SANCTUARY OF PEACE RESIDENTIAL COMMUNITY PUD DEVELOPMENT PLAN / PRELIMINARY PLAT

DEVELOPMENT PLAN COVER SHEET

PUDSP-19-002

PUDSP V_2 redlines.pdf Markup Summary 10-16-2019

DEVELOPMENT PLAN
PRELIMINARY UTILITIES

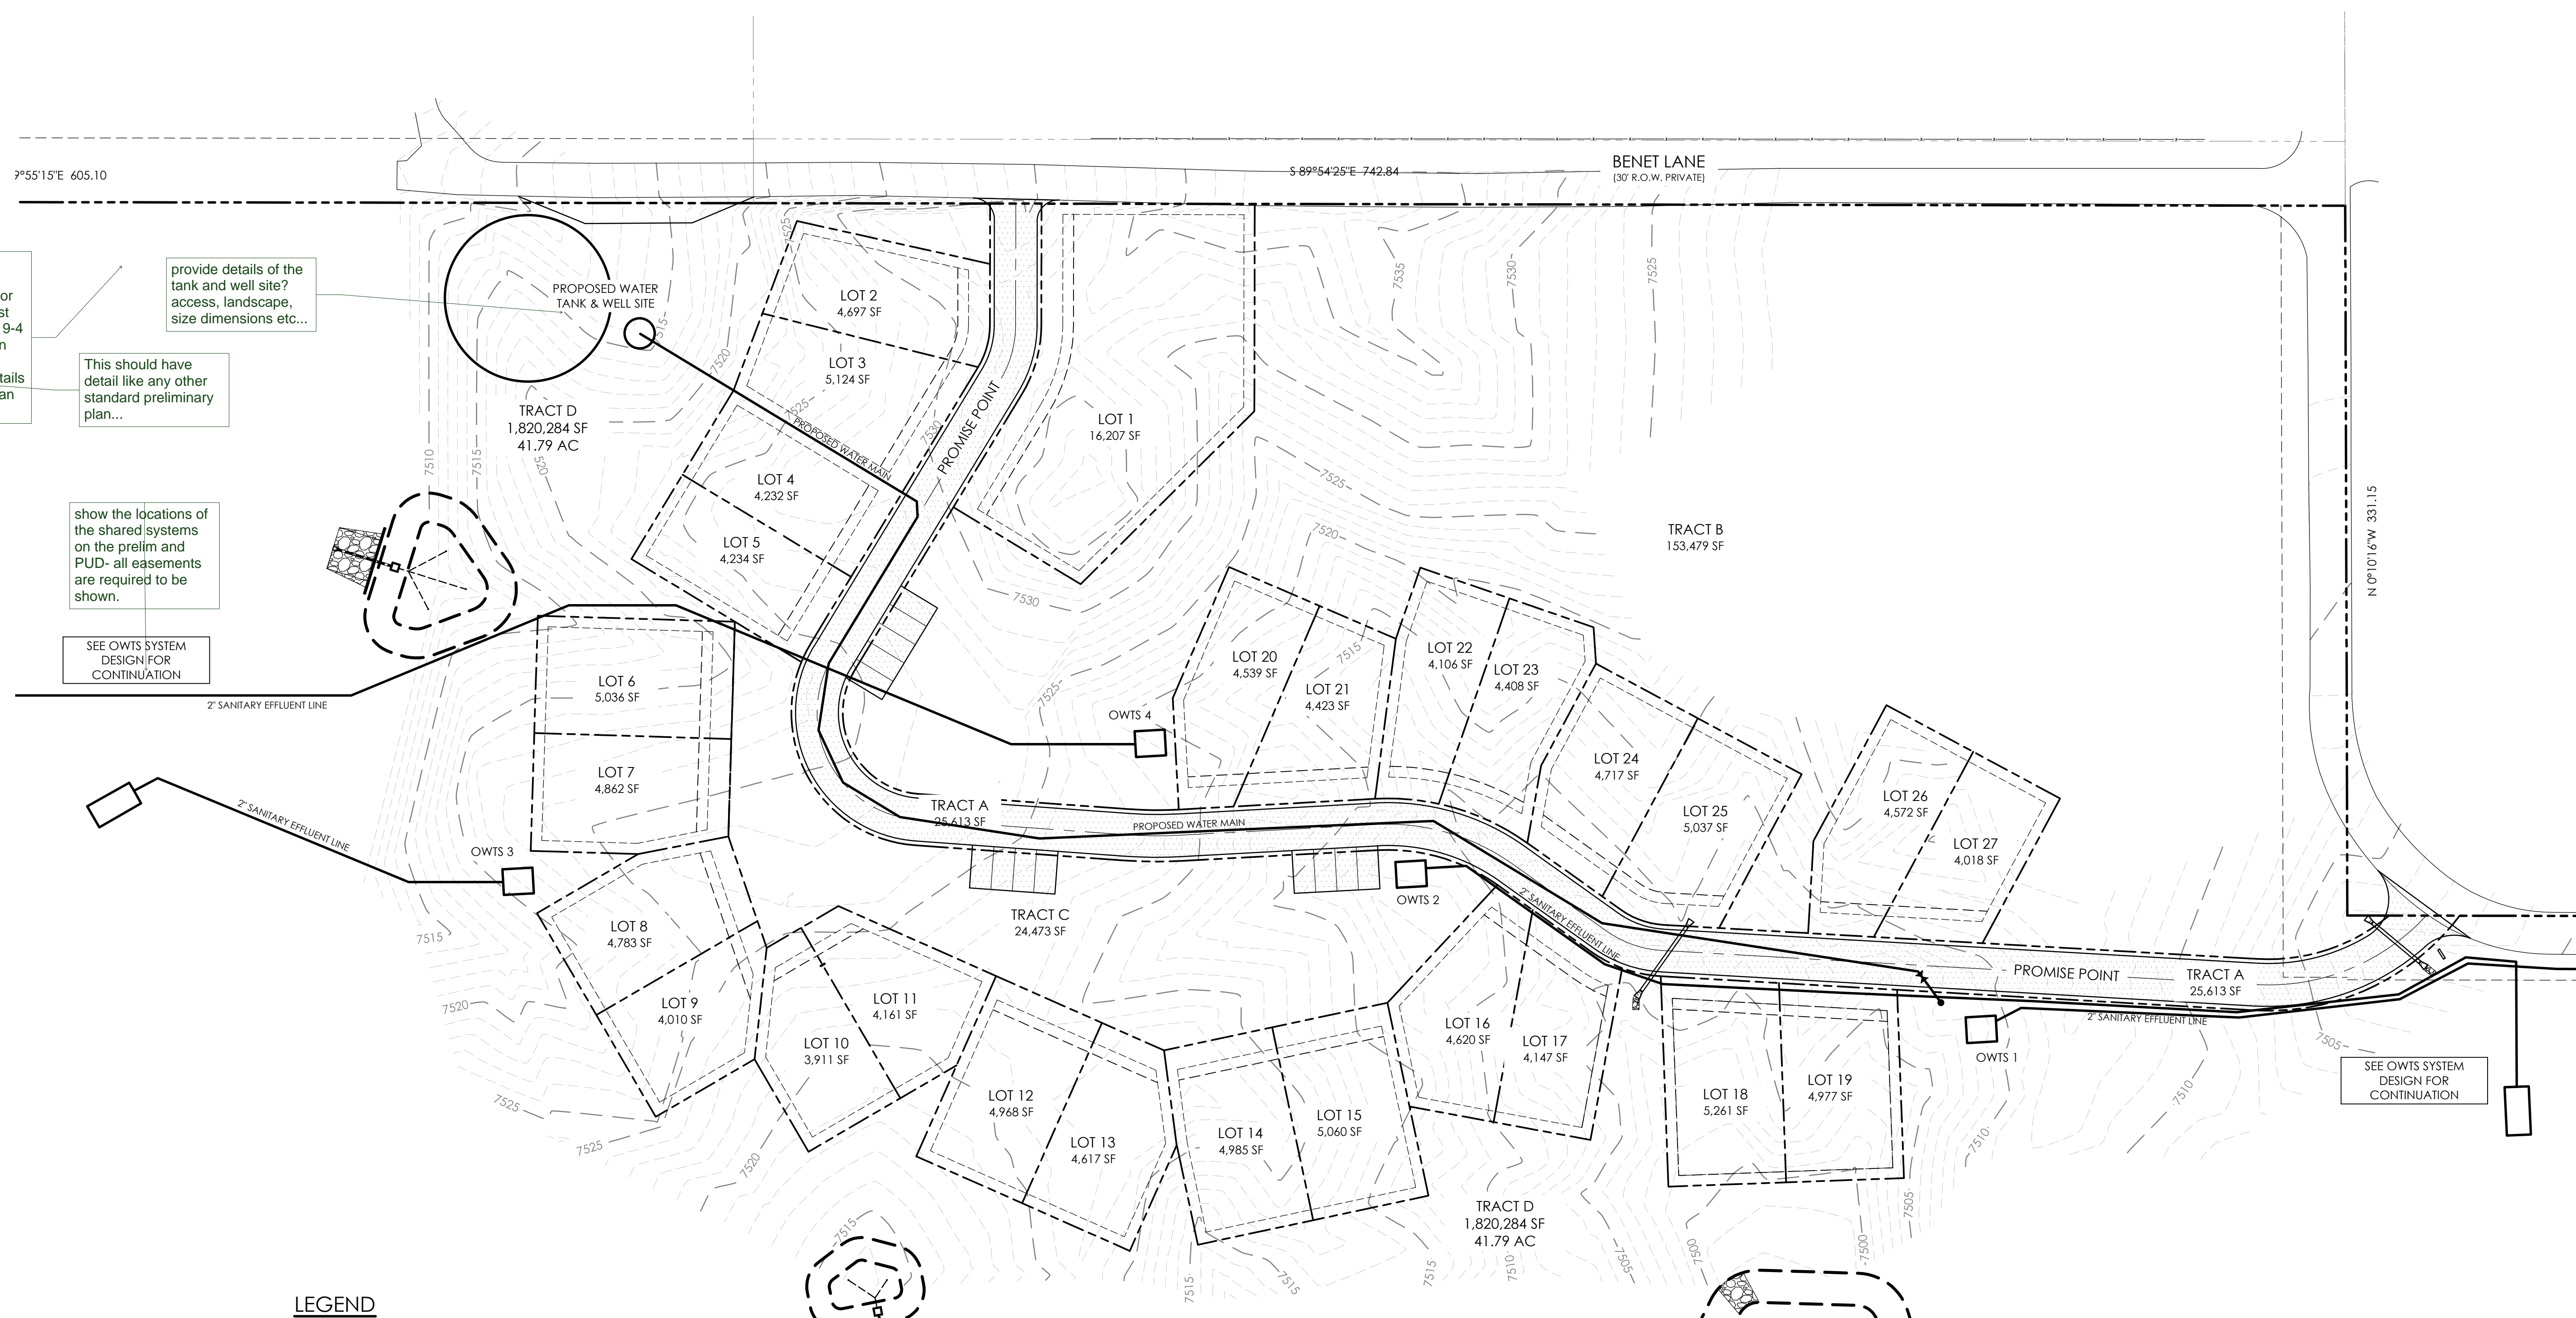
Show the locations of the shared systems on the prelim and PUD- all easements are required to be shown.

This should have detail like any other standard preliminary plan...

provide details of the tank and well site? access, landscape, size dimensions etc...

take a look at PUDSP8-001 Recorded PUDSP or PUDSP19-6 Forest Lakes or PUDSP19-4 Midtown Collection Hannah Ridge for samples of the details required for the plan set.

DEVELOPMENT PLAN
LANDSCAPE PLAN

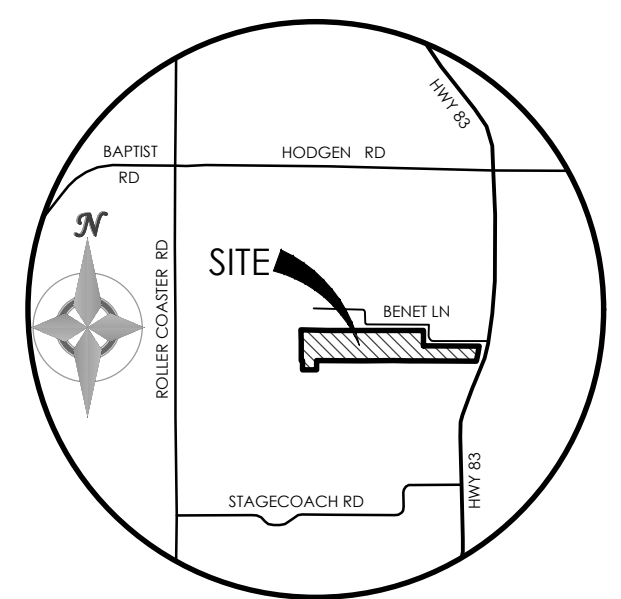
title all sheets

fence detail, ?
retaining wall detail?

provide tree types, shrub types, cloud areas to remain and areas to be removed, provide seed mix for revegetation.
